HENDERSON COUNTY TECHINCAL REVIEW COMMITTEE

SUBJECT: Combined Master and Development for Oakwood Acres, Major Subdivision (2017-M05)

Henderson County Planning Department Staff Report

Combined Master and Development Plan Oakwood Acres (2017-M05)

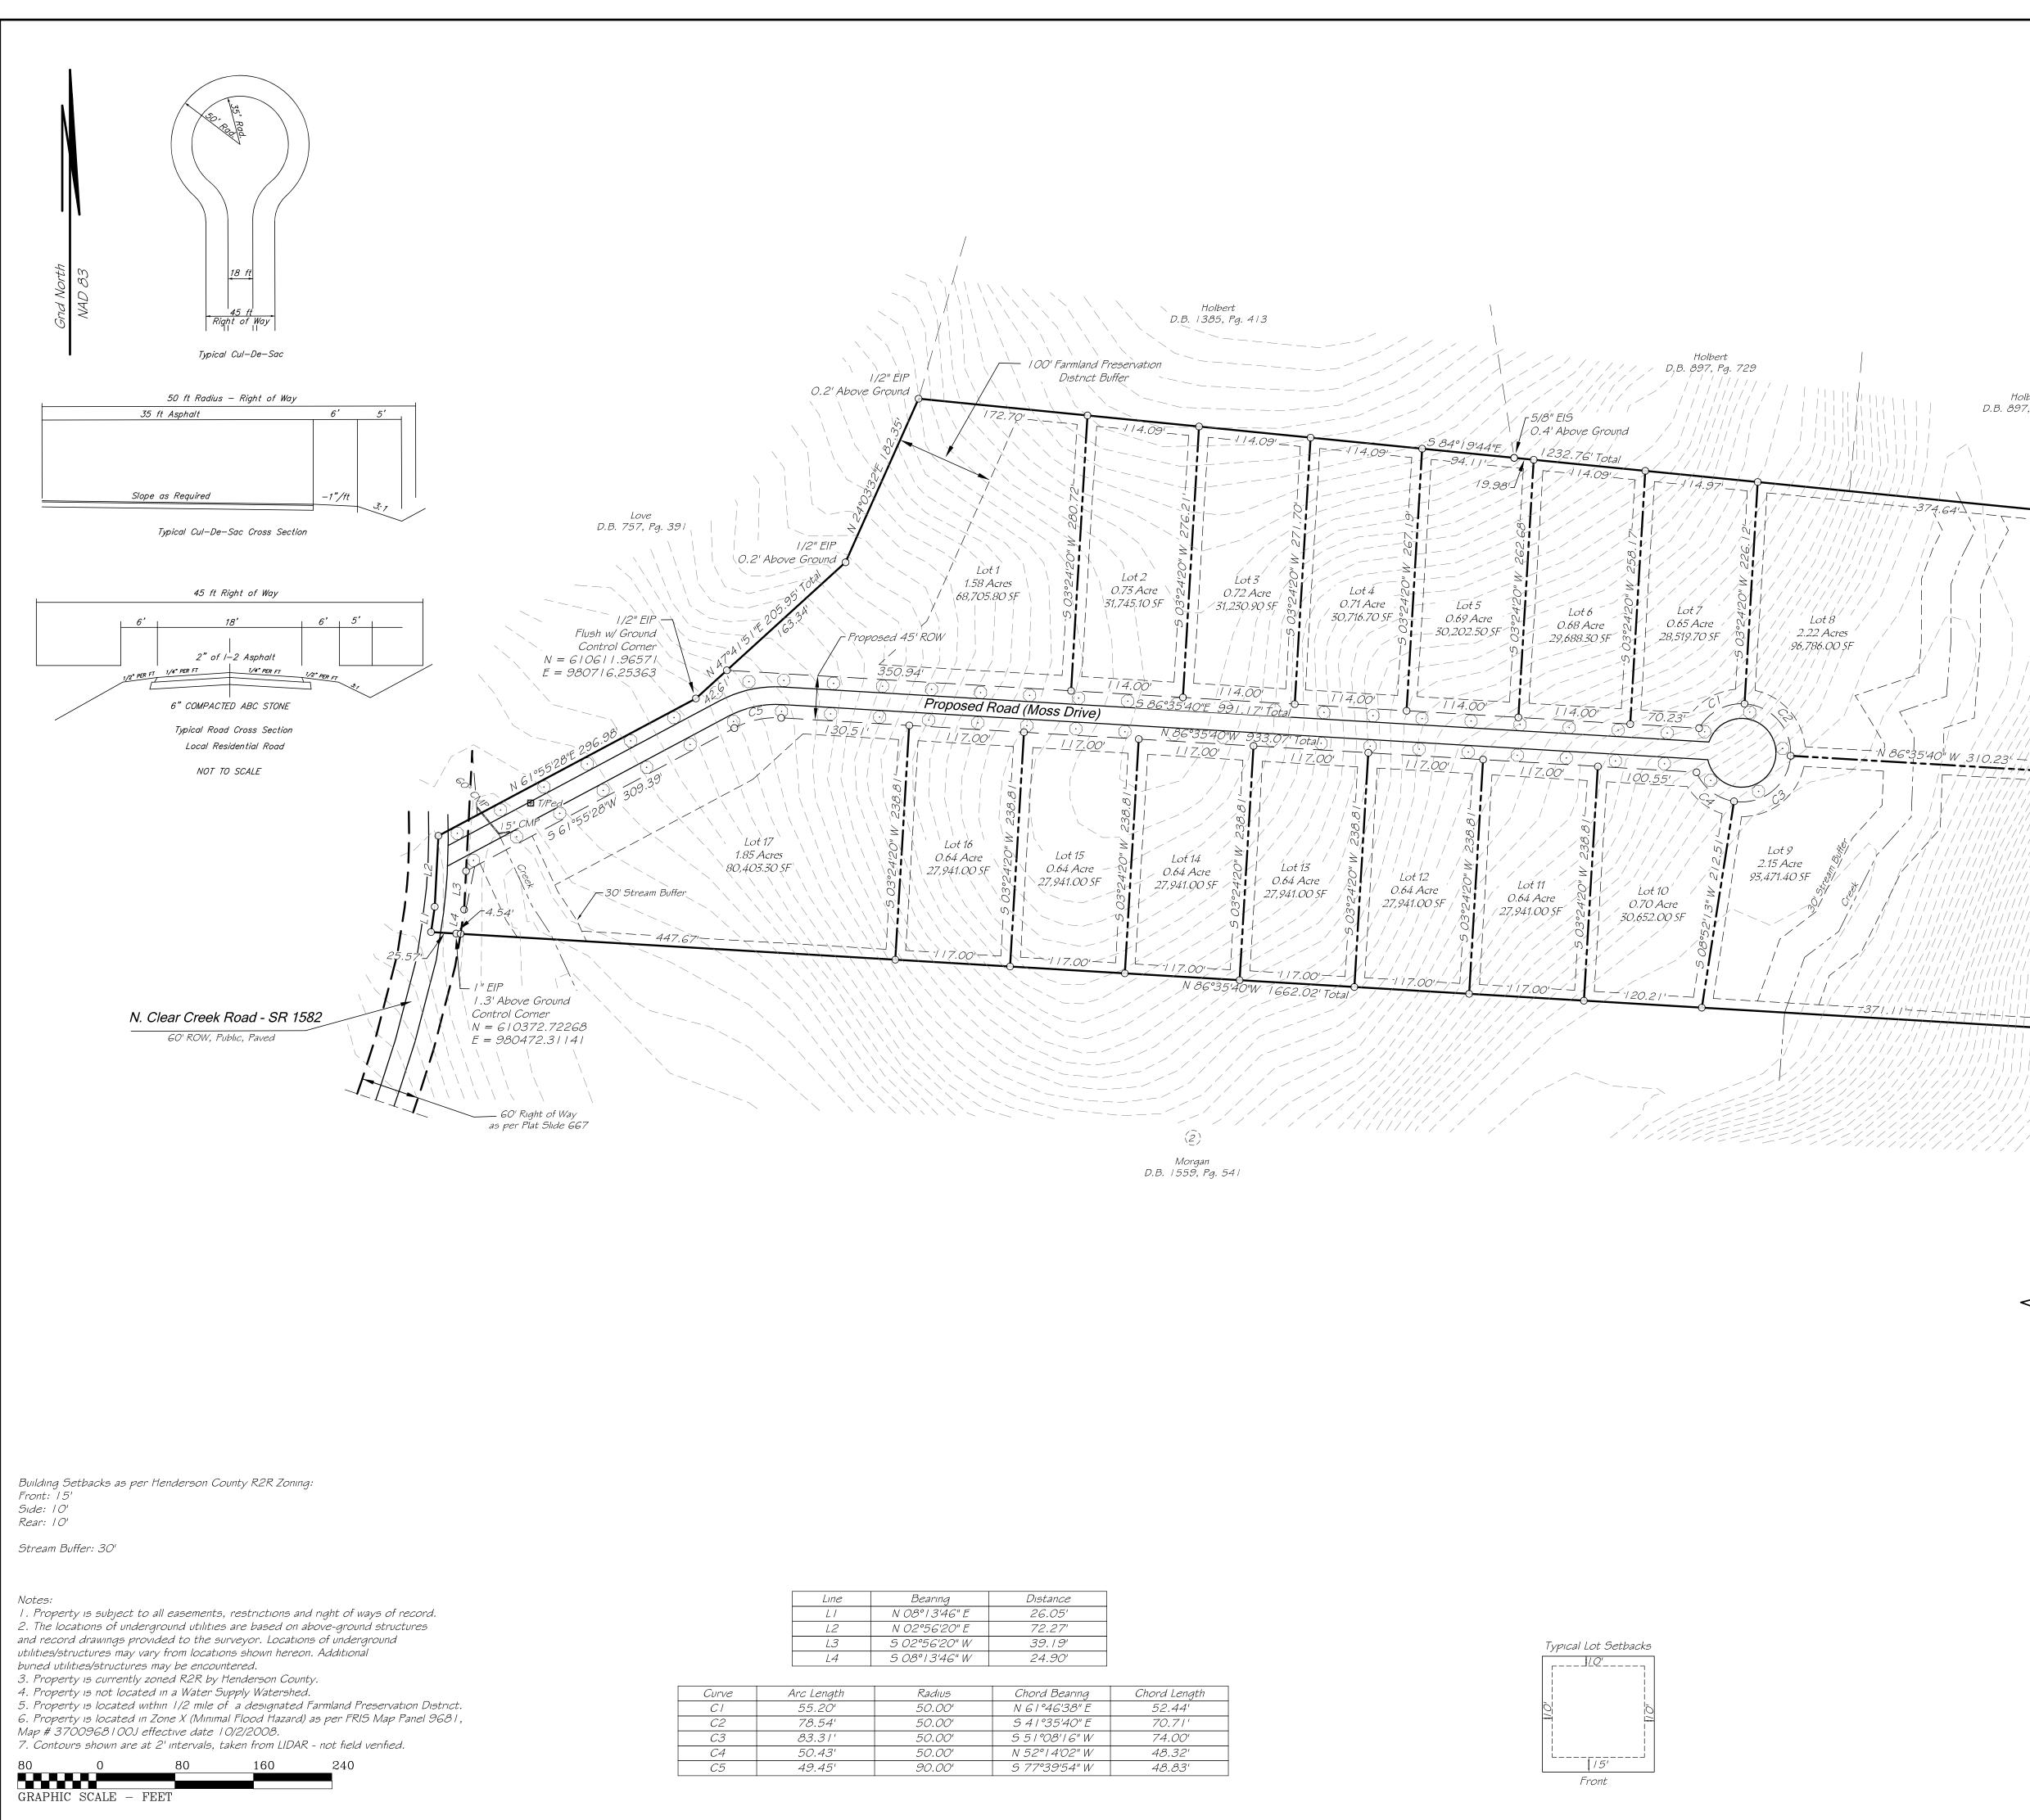
- 2. **Public Roads.** The final plat(s) must indicate that the proposed road (Moss Drive) has been designed and constructed in accordance with State Road Standards and has been offered dedication to the public

- 4. **Road Drainage, Culverts and Shoulder Stabilization.** Road or drainage structures shall be constructed in accordance with state roads standards. Road drainage side ditches shall be constructed

with sufficient depth and width to carry the expected volume of storm water runoff (LDC §42A-100). All areas disturbed by the construction of a public road, including cut and fill slopes, shoulders and ditch banks, shall be seeded to stabilize the soil and prevent erosion. Seeding should be done as soon as feasible after road construction (LDC §42A-97).

- 5. **Road Name Approval.** Proposed road names for a private and/or public road shall be preapproved by Henderson County in accordance with Chapter 42 of the Henderson County Code, Property Addressing (LDC §42A-98). The applicant lists the proposed road names for most road segments. The names of the shared drives should be confirmed with the development plan approval.

- 6. **Street Tree Requirements.** According to the street tree requirements of Chapter 42A (LDC §42A-145 and LDC §42A-146) the applicant must provide one tree per 50 linear feet of property abutting an internal road. Trees may be placed in groups with a minimum spacing of no less than 15 feet and a maximum spacing of no more than 65 feet. The trees may be placed within the right-of-way or within 20 feet of the edge of the right-of-way. The applicant may use existing trees in accordance with LDC §42A-153 instead of planting new trees. These existing trees must also be located within the right-of-way or 20 feet off the edge of the right-of-way as required by LDC §42A-146

- Farmland Preservation. In accordance with the Farmland Preservation District Setback requirements of Chapter 42A (LDC §42-113) a minimum 100 foot setback for all buildings or structures is required from any Farmland Preservation District. Also Subdivisions located adjacent to a Farmland Preservation District should be developed using §42-88 Conservation Subdivision Standards.
